RE: CARPET MAX (K21-D16L). GRADING AND DRAINAGE PLAN FOR BUILDING PERMIT APPROVAL. ENGINEER'S STAMP DATED OCTOBER 8, 1997.

RE: CARPET MAX (K21-D16L). GRADING AND DRAINAGE PLAN FOR BUILDING PERMIT APPROVAL. ENGINEER'S STAMP DATED AUGUST 21, 1997.

**RE: GRADING & DRAINAGE PLAN FOR APPLEBEE'S - LOMAS (K21-D16L)
RECEIVED MAY 19, 1995 FOR BUILDING PERMIT
ENGINEER'S STAMP DATED 5-19-95**

RE: GRADING & DRAINAGE PLAN FOR APPLEBEE'S - LOMAS (K21-D16L)
RECEIVED APRIL 24, 1995 FOR BUILDING PERMIT
ENGINEER'S STAMP DATED 4-25-95

PROJECT APPLE BEES
SUBJECT Drainage Calcs
BY GJK DATE 4-21-95
CHECKED _____ DATE _____
SHEET 5 OF _____

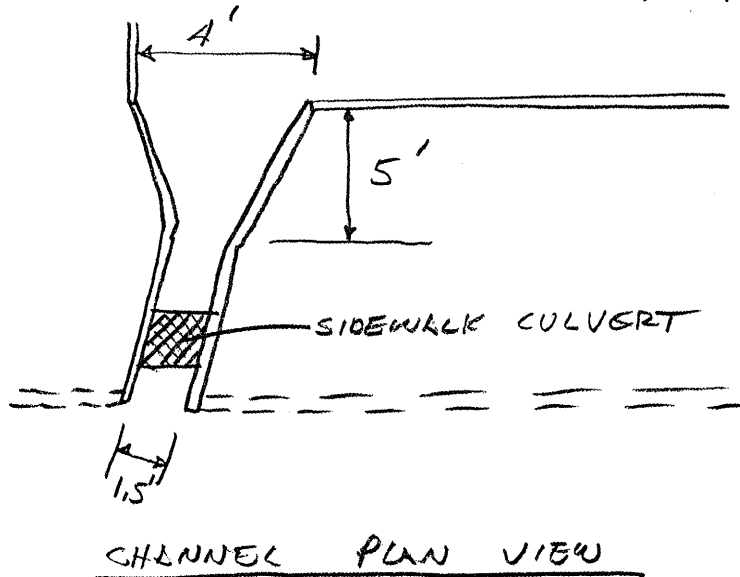
According to the Espey, Huston & Assoc Plan, Dated 7-27-89, Basin C-7 has an area of 3.8 acres. Based on 90% D for Hotel Ave and 80% D for developed Tract 2-A-1, then Basin C-7 would be 14% B, 3% C & 83% D. These land treatment percentages and the original area will result in a Q that is much closer to the EHA Plan than the calculations submitted.

- CALCULATE RUNOFF FOR ENTIRE C-7 BASIN

USE 14%
3%
83%
Report of EPEY
HOUSTON PLAN

Q = 16.55 CFS
V = 0.6343 AC-FT

SINCE 16.55 CFS < 18.1 CFS ALLOWABLE FOR BASIN

CARPET MAX GRADING AND DRAINAGE PLAN

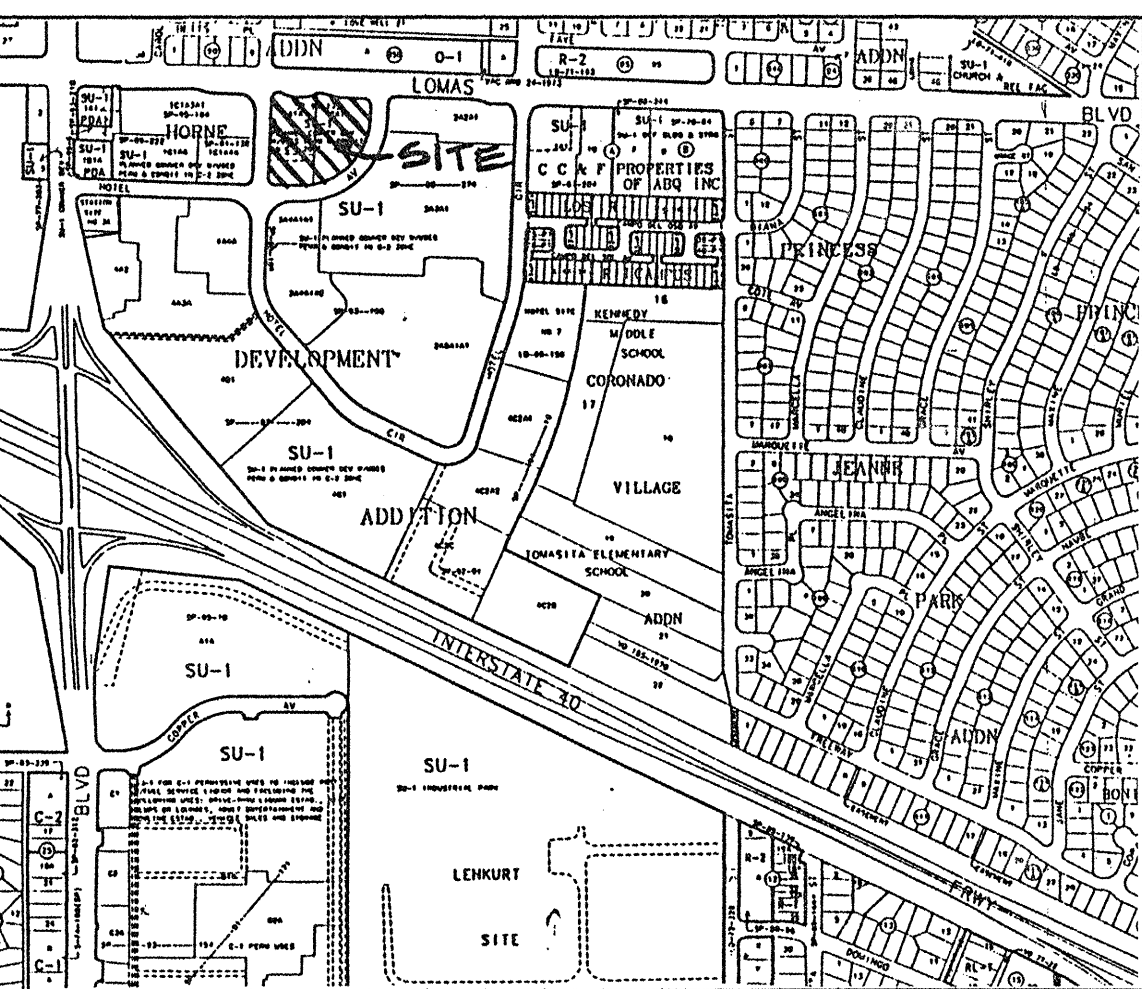
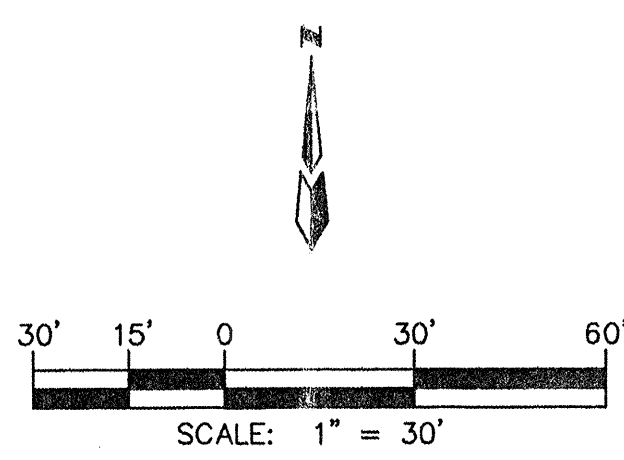
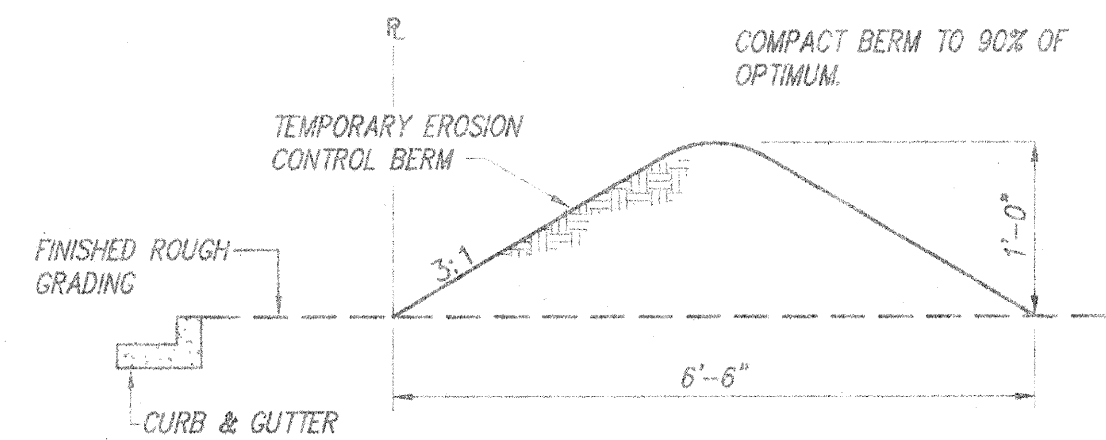
1. A cross lot drainage easement will be required.
2. A one-foot water block at the drive way will be required. If this is not possible, discuss other options. Do not omit spot elevations in the drive.
3. It appears that this site is zoned SU-1. Therefore, a site development plan will be required.

APPLEBEE'S - LOMAS
GRADING & DRAINAGE

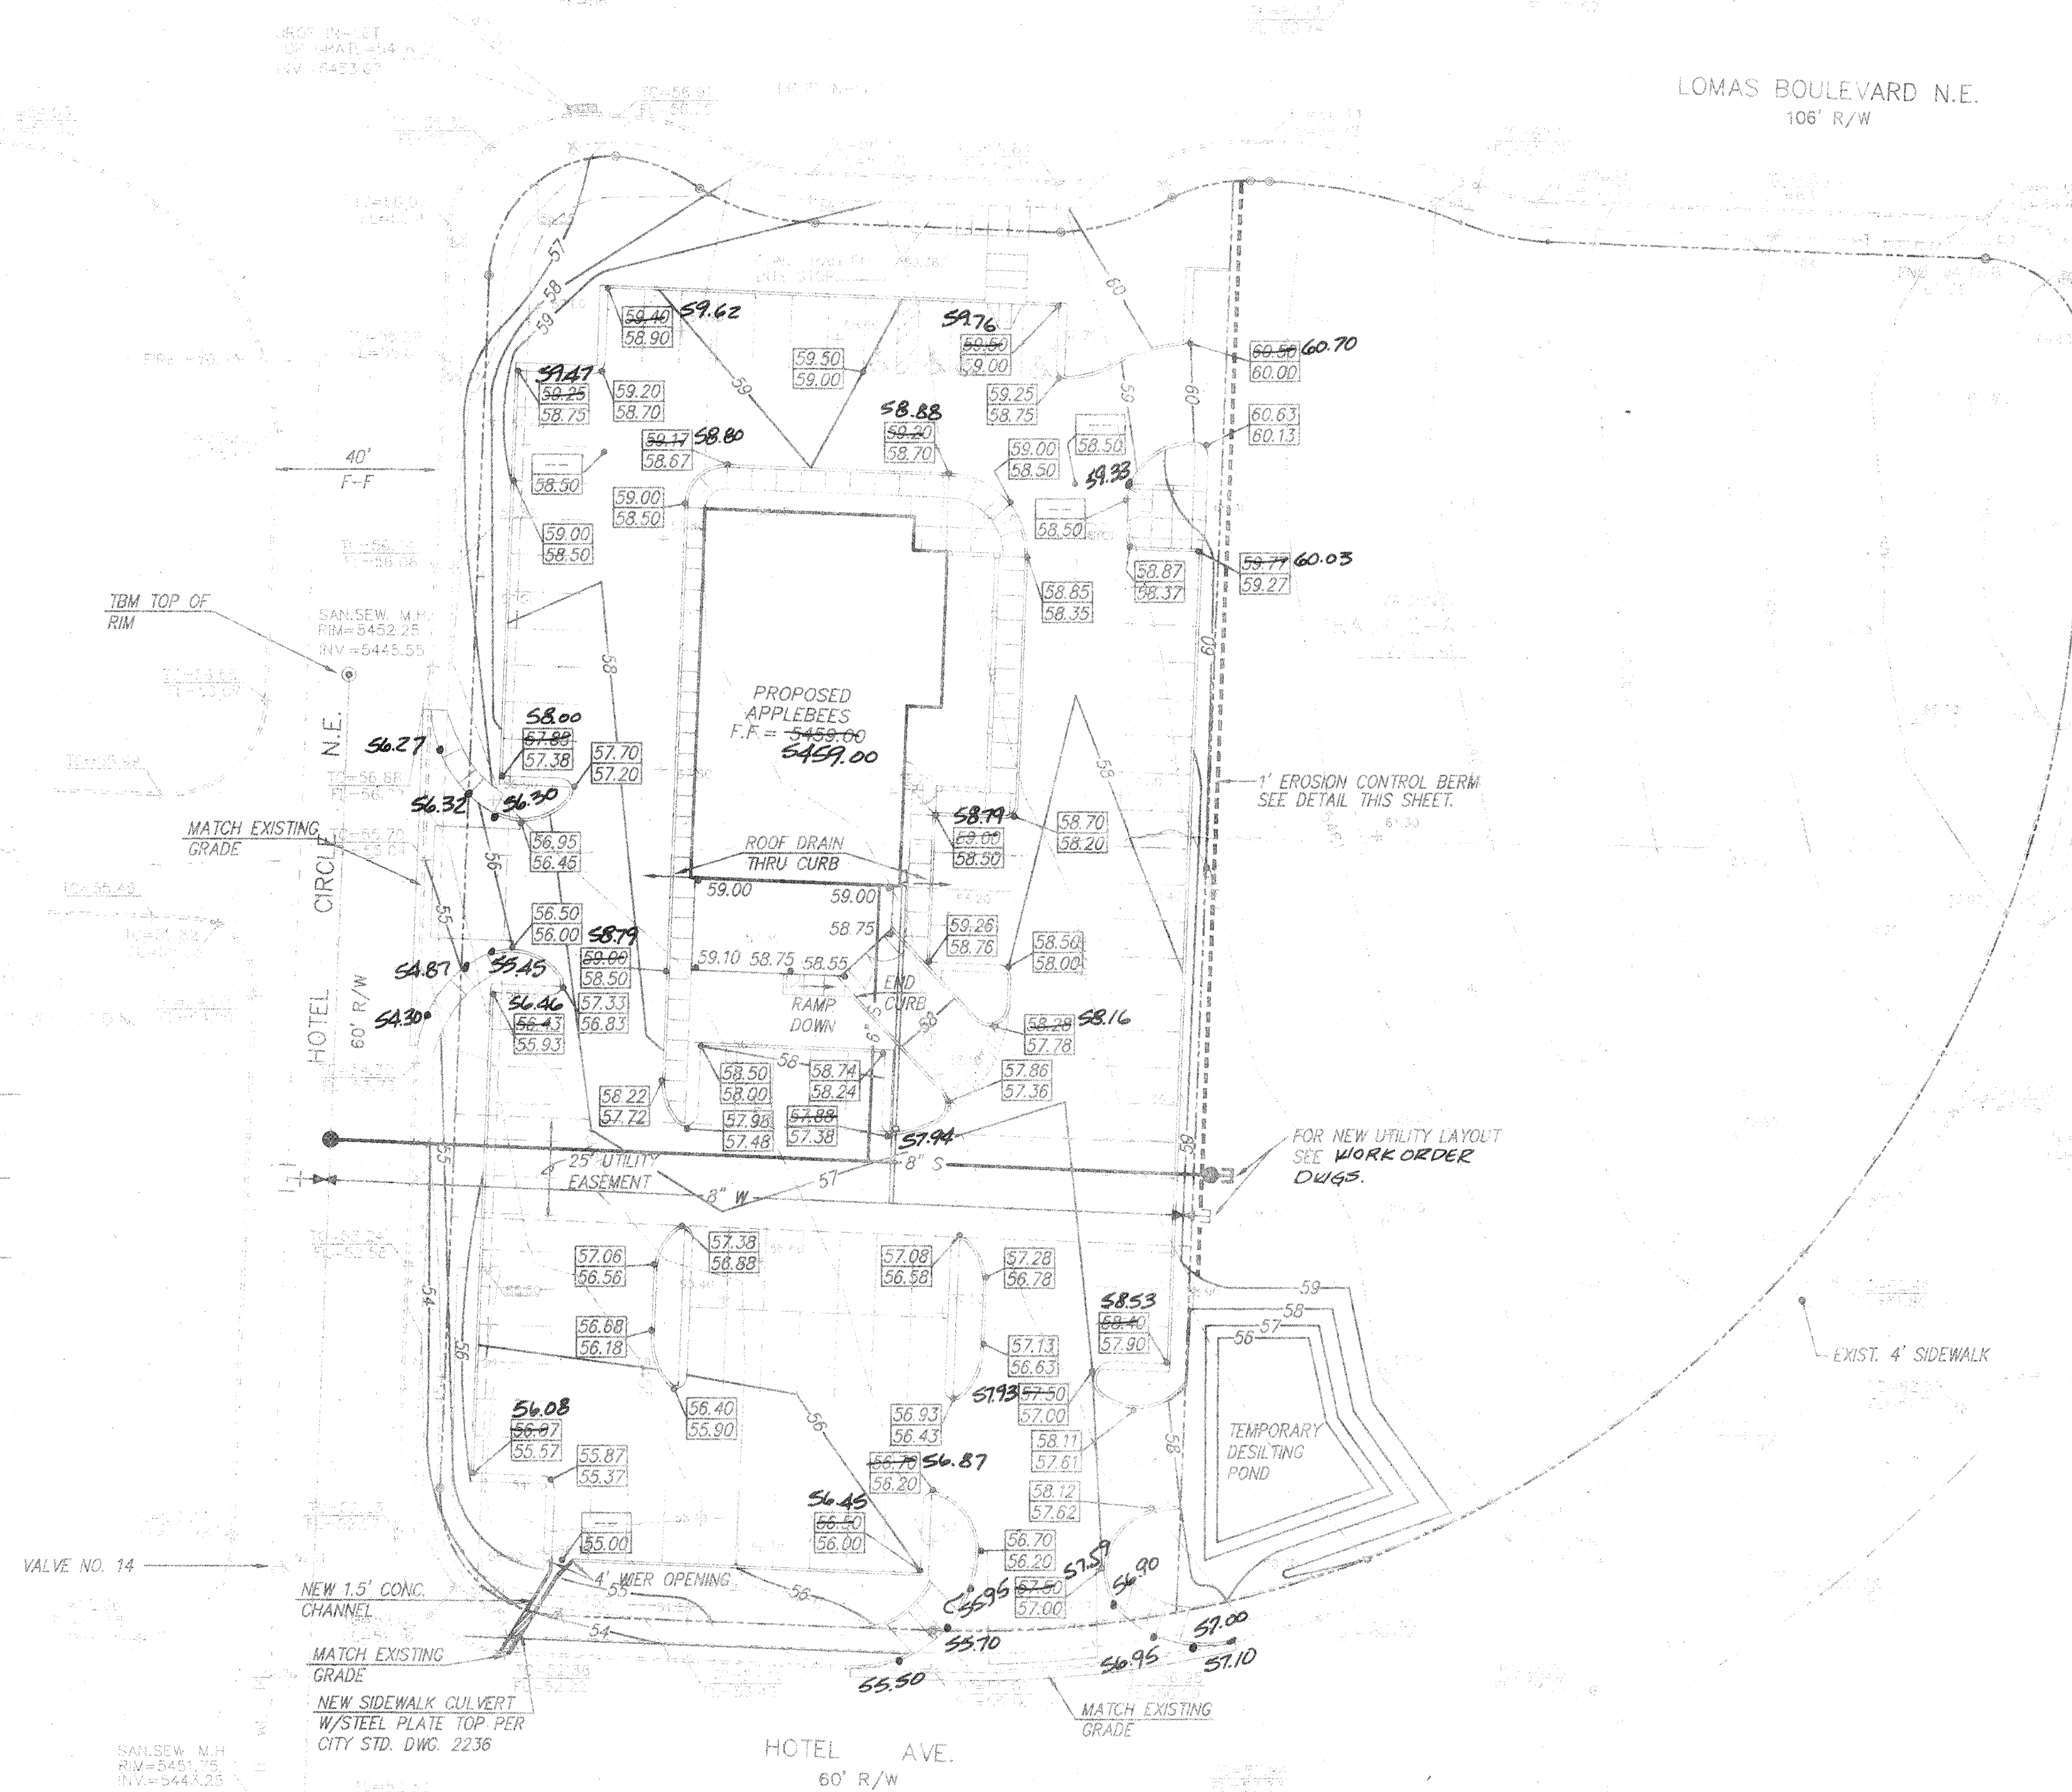
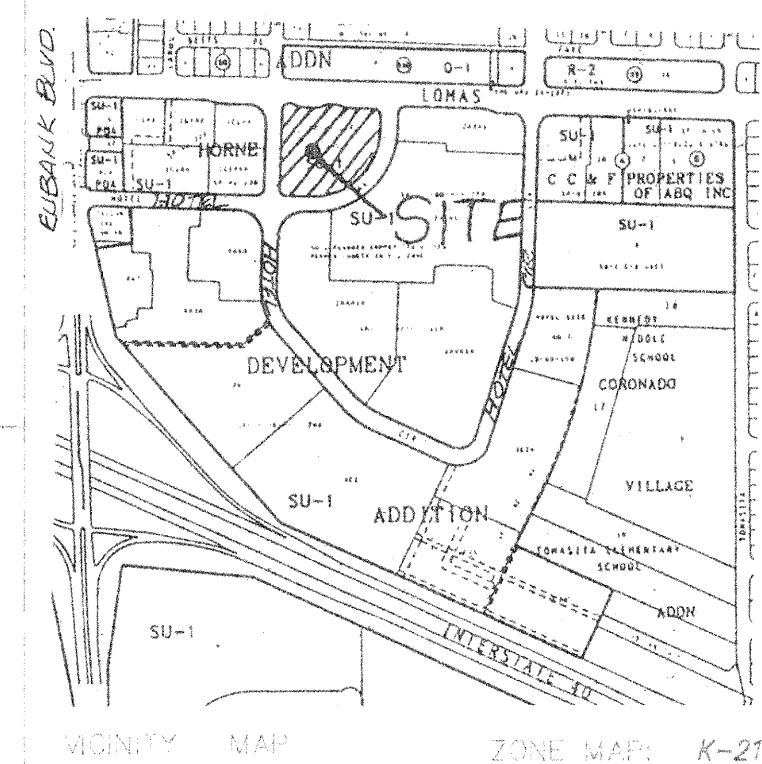
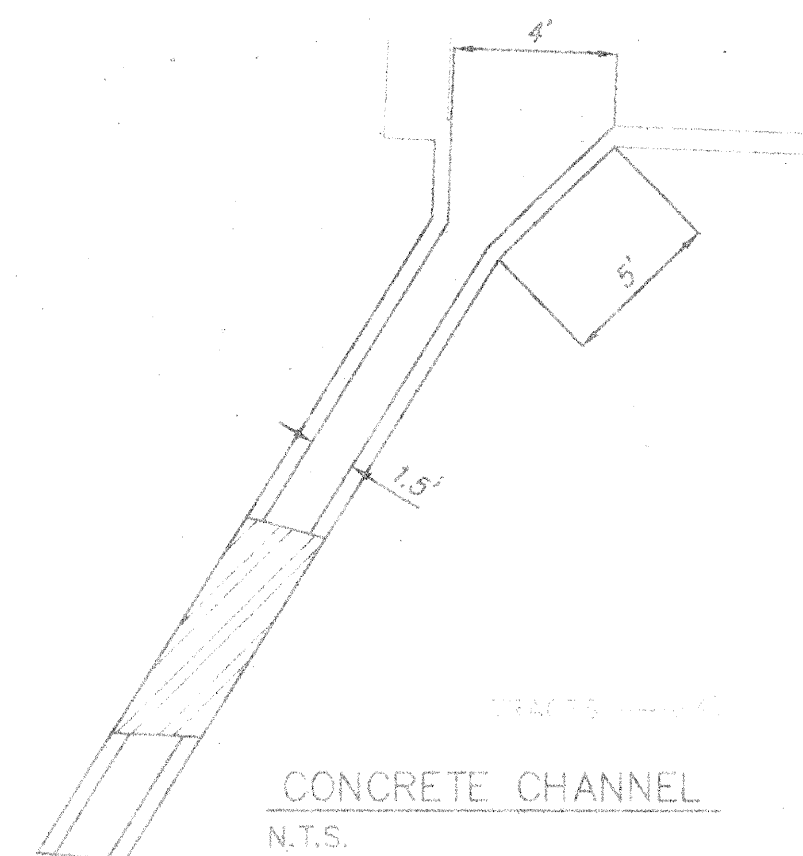
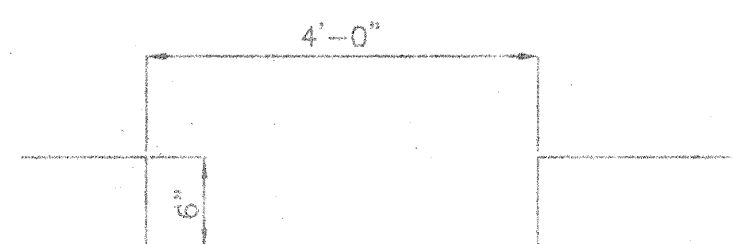
If the eastern portion of Tract 2-A-1 drains through the proposed entrance on Hotel Ave, then a Private Drainage Easement will be required when the Tract is split.

Tract 2-A-1 is zoned SU-1. Is there a Site Development Plan for this project? If Tract 2-A-1 is to be replatted, include the proposed infrastructure list and the DRB number in the next submittal. Include the Erosion Control Plan on the Grading & Drainage Plan. What erosion control measures are required between the developed & undeveloped portions of Tract 2-A-1?

Based on Sheets 12 & 13 from the Espey, Huston & Assoc Conceptual Grading & Drainage Plan for Market Centre East (K21-d16), dated 7-27-89, Hotel Avenue is included in Basin C7 which has a total area of 3.8 acres. Subtract the developed flow for Hotel Avenue from the allowable flow for Basin C7 before calculating the allowable flow for Tract 2-A-1. Where will the eastern portion of Tract 2-A-1 drain to?
